**From:** "JAMAR, Brandon" <btj@nei.org>  
**To:** "Charles Moulton" <CEM4@nrc.gov>, "Sunil Weerakkody" <SDW1@nrc.gov>, <RHG@nrc.gov>  
**Date:** Mon, Jun 4, 2007 8:34 PM  
**Subject:** FAQ 06-0017 Rev. 2 for submittal

FAQ Number 06-0017

**FAQ Title Ignition Source Counting Guidance for High Energy Arching Faults**

**FAQ Number**    06-0012 Revision 4

Figure B-4 General Process to Transition Operator Manual Actions

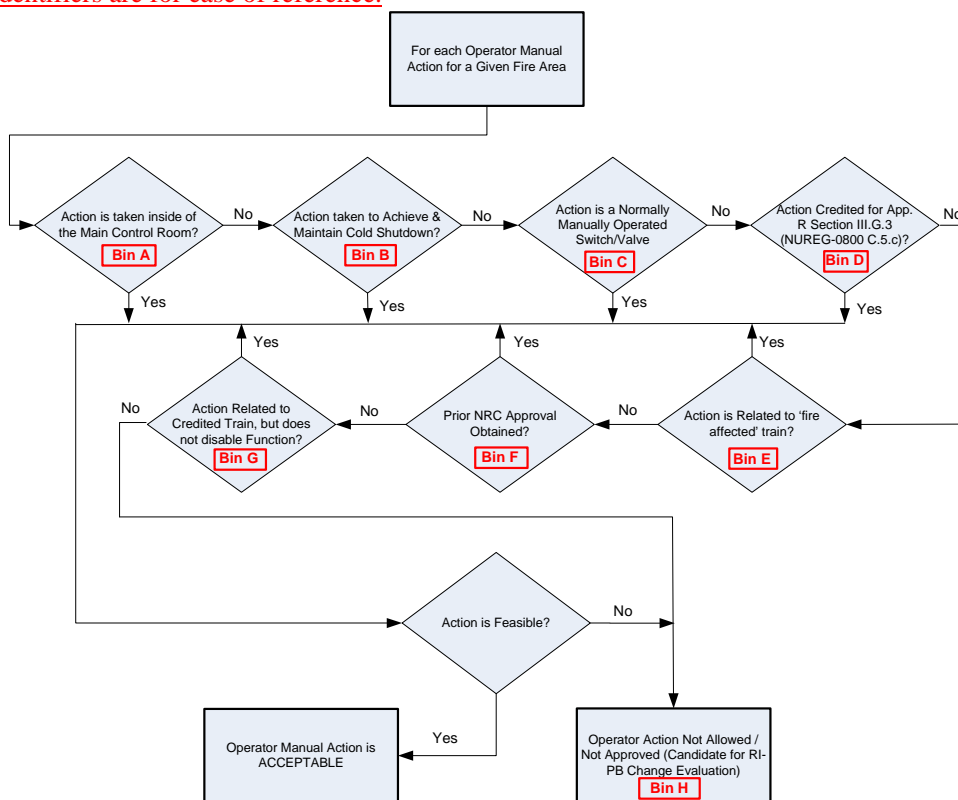
Figure B-4 depicts this general process for determining whether a transitioning operator manual action to NFPA 805 recovery action requires a change evaluation. The ‘bin’ identifiers are for ease of reference.

**Figure B-5 Allowed Operator Manual Action in Fire Area Meeting 10 CFR 50, Appendix R, Section III.G.1 Separation Criteria**

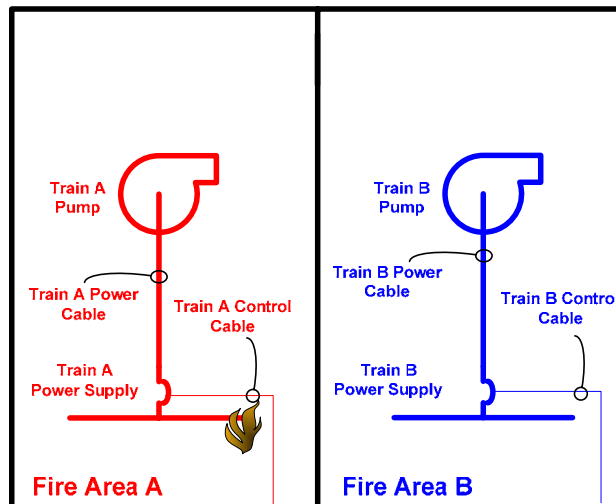
- Operation of fire affected equipment for fire areas that meet the separation requirements of Section III.G.1 of 10 CFR 50, Appendix R (or applicable sections of NUREG-0800). See Figure B-5. [Bin E]

Fire Area A and B meet the separation criteria of 10 CFR 50 Appendix R Section III.G.1. A postulated fire in Fire Area A could result in the spurious starting of the Train A pump, which can be mitigated by an operator manual action to de-energize the Train A Power Supply to stop Pump A.

**Figure B-6 Allowed Operator Manual Action in Fire Area Meeting 10 CFR 50, Appendix R, Section III.G.2 Compliant – Operator Manual Action for Fire Affected Train**

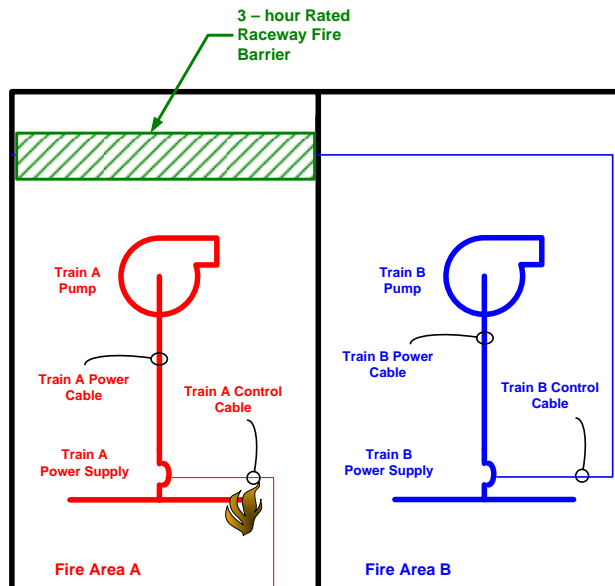
- Operation of fire affected equipment for fire areas that meet the protection requirements of Section III.G.2 of 10 CFR 50, Appendix R (or applicable sections of NUREG-0800) for redundant trains. See Figure B-6. [Bin E]

Fire Area B meets the separation criteria of 10 CFR 50 Appendix R Section III.G.2.a. A postulated fire in Fire Area A could result in the spurious starting of the non-credited Train A pump, which can be mitigated by an operator manual action to de-energize the Train A Power Supply to stop Pump A. This is functionally equivalent to Case in Figure B-5.

**Figure B-7. Allowed Operator Manual Action – In Credited Success Path – Common Tank Suction**

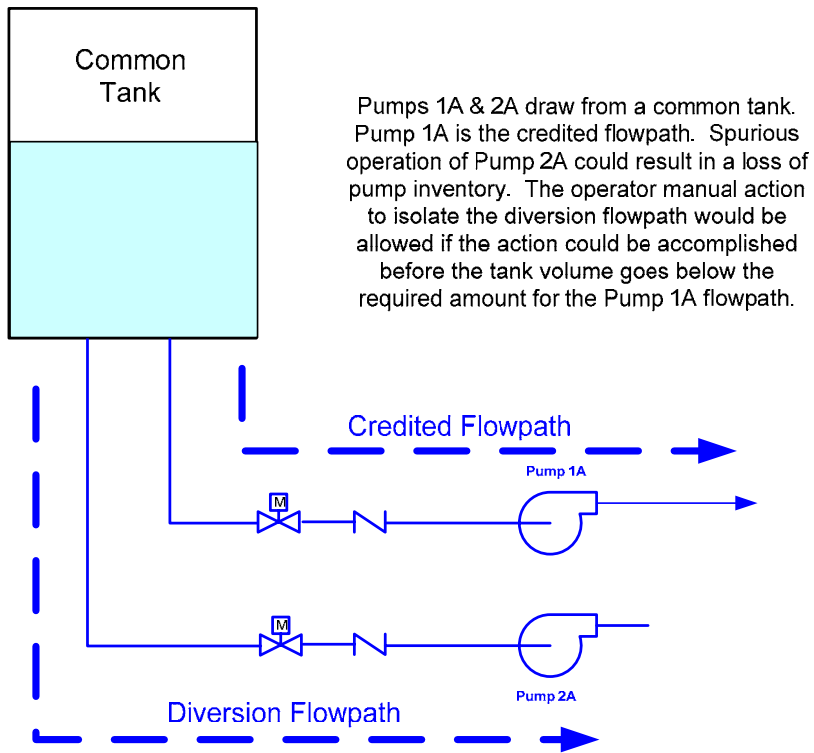
During the June 9, 2006 public meeting the following example was specifically discussed: Two redundant trains taking suction from a common tank. Provided the manual action can be accomplished prior to the tank volume going below the minimum required volume to support the credited function the action would be allowed and therefore not require a change evaluation. (Figure B-7)

Figure B-8, Allowed Operator Manual Action – In Credited Success Path – Auxiliary Feedwater Flow Diversion

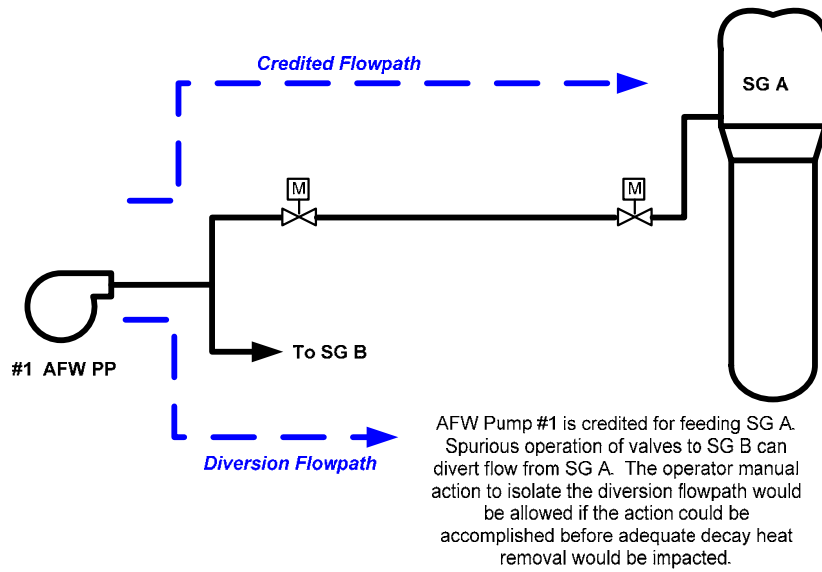
A second example is the credited function is to inject water to the Steam Generator (reactor) and a spurious actuation causes a diversion from the credited flow path. Provided the minimum required injection flow can be maintained and the operator action can be accomplished prior to the function being disabled. (Figure B-8)
